# UNITED STATES PATENT AND TRADEMARK OFFICE

10/689,247

**Office Action Summary**

## DETAILED ACTION

FIG. 9

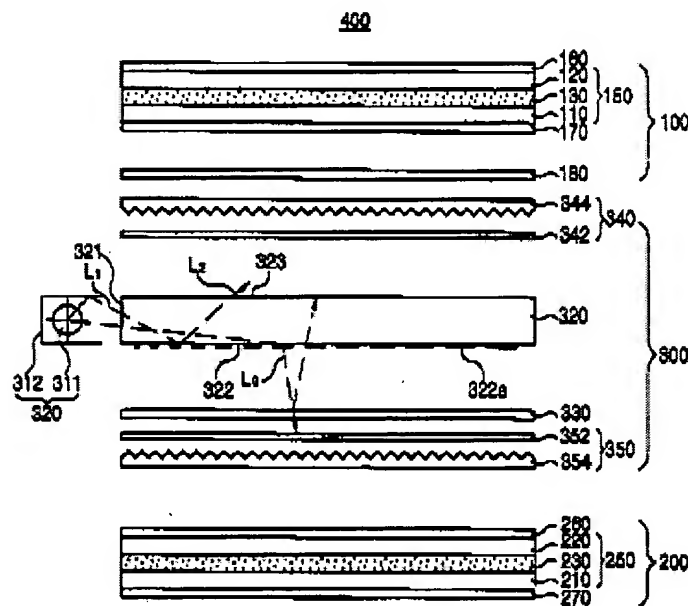
5. Choi discloses and shows in Fig. 1, a double-sided emissive LCD module comprising:

- a double-sided illumination plate ;
- a first LCD display panel (250) disposed at an upper surface of the double-sided illumination plate;

- a second LCD display panel (150) disposed at a lower surface of the double-sided illumination plate;

the double-sided illumination plate comprising:

- a light source (311);
- a light guide plate (320) for emitting light guided from the light source onto the first and second surfaces; and
- a transflector (180) disposed on a surface of the light guide plate (320) facing the second LCD panel (150),

wherein the transflector reflects a part of the light emitted from the light guide plate to the first LCD panel and transmits the rest of the light to the second LCD panel.

Accordingly, Claim 1 is anticipated.

As to claim 4, Choi also shows in Fig. 9 that a prism sheet (354) is disposed between the double-sided illumination plate and the first LCD panel (250).

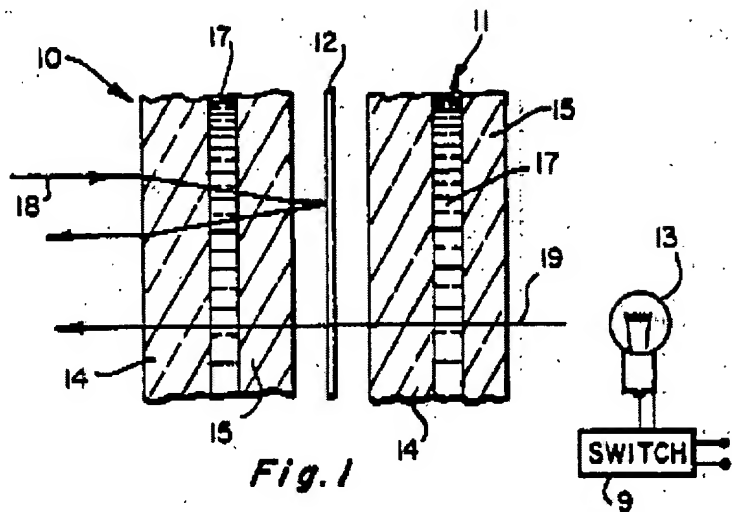
11. Haim discloses and shows in Fig. 1, a dual liquid crystal display device comprising:

- a first display unit including:
  - o a first liquid crystal display panel having a first substrate (14), a second substrate (15) and a first liquid crystal layer (17) between the first and second substrates; and
  - o a transfective film (12) disposed under the first liquid crystal display panel, so that the transfective film partially reflects and partially transmits an incident light incident onto the transfective film;

- a second display unit including a second liquid crystal display panel having a third substrate (14) and a fourth substrate (15) and a second liquid crystal layer (11) between the third and the fourth substrate; and
- a light supplying unit (13).

Haim differs from the claimed invention because he does not explicitly disclose that the light supplying unit is double sides illumination plate and is disposed between the first and second display units.

Yamauchi shows in Fig. 3, a dual liquid crystal display panel wherein a light supplying unit (5) disposed between the first and second display units (1 and 11), wherein the light supplying unit including a light source (6) and a light guide plate (7) for emitting light guided from the light source onto the first and second surfaces. Yamauchi further discloses that such an arrangement is advantageous since it increases an efficiency of utilizing light of the illumination apparatus and bright two faces display is obtained (col. 2, lines 47-56).
